Proposed Revisions to a Standard Plans Index

Index Number: 455-030

Index Title: 30" SQUARE PRESTRESSED CONCRETE PILE

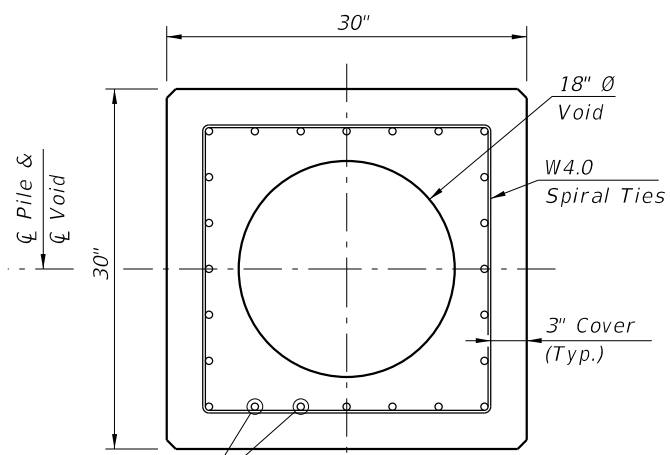
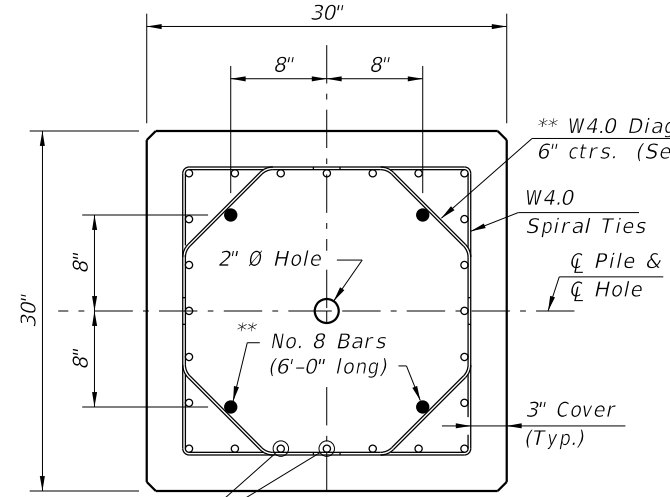
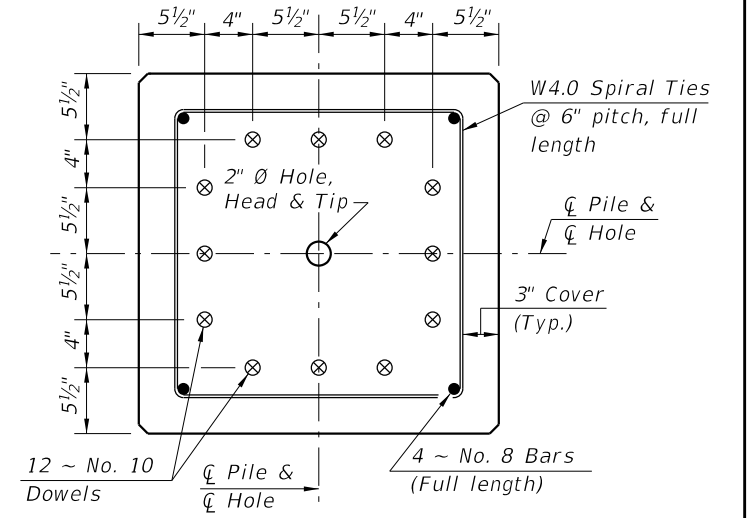
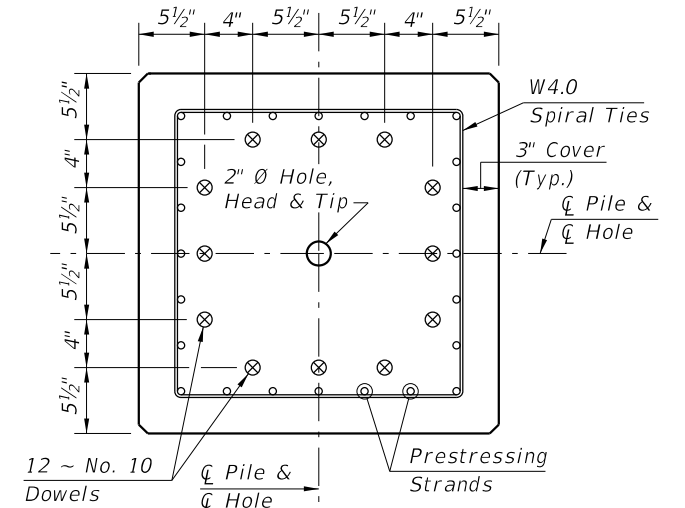
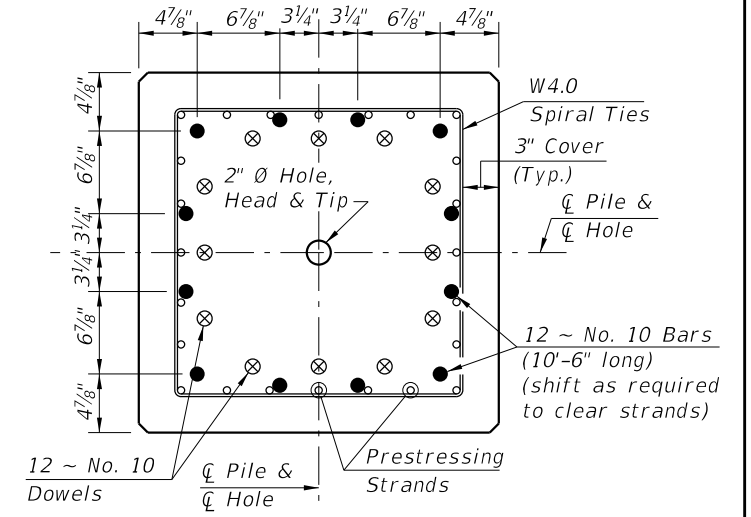
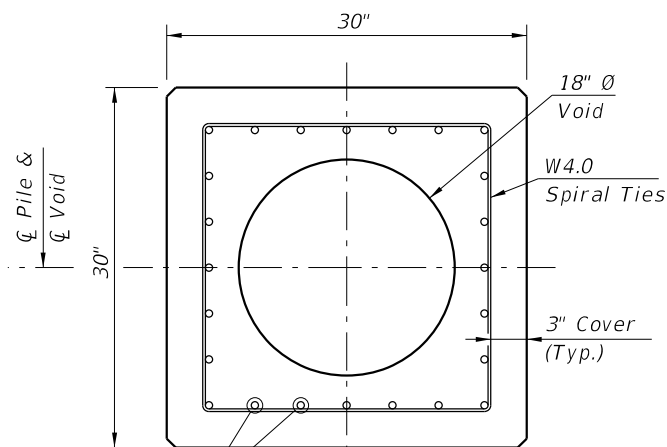
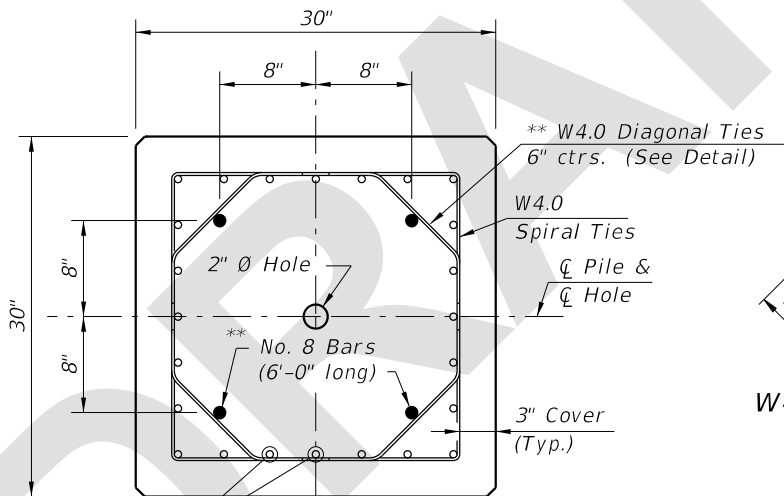
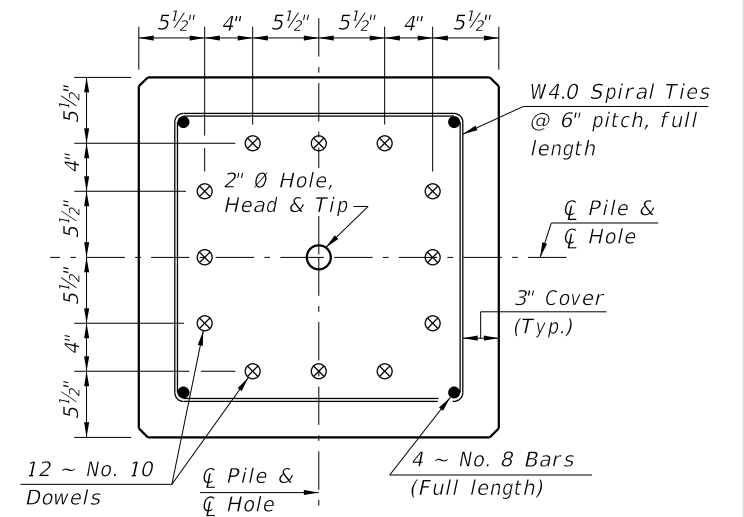
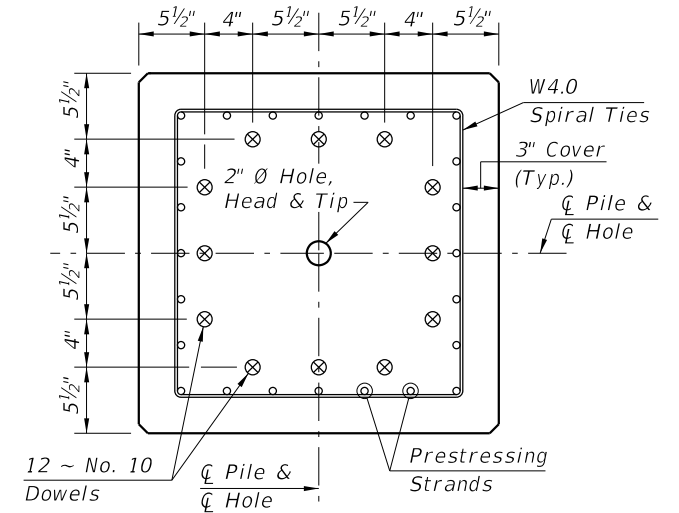
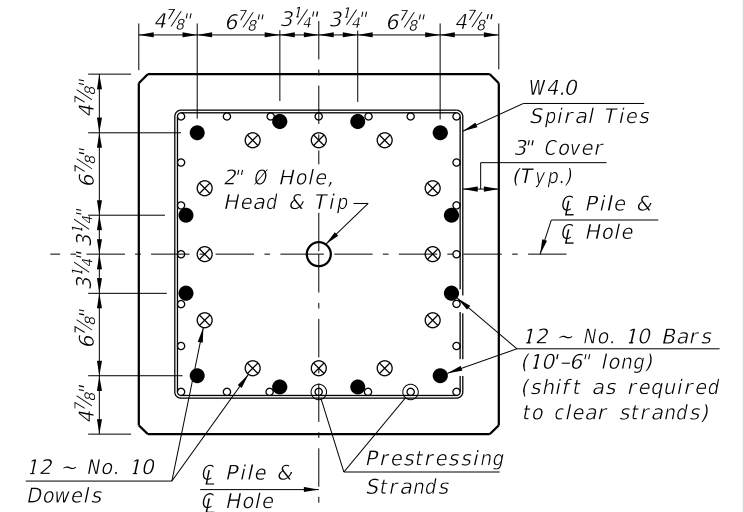
Reverted to the previous version of the Standard.

- Work this Index with Index No. ~~20600~~ - Notes and Details for Square Prestressed Concrete Piles and Index No. ~~20601~~ - Square Prestressed Concrete Pile Splices.

455-002 → 455-001

- Work this Index with Index 455-001 - Notes and Details for Square Prestressed Concrete Piles and Index 455-002 - Square Prestressed Concrete Pile Splices.
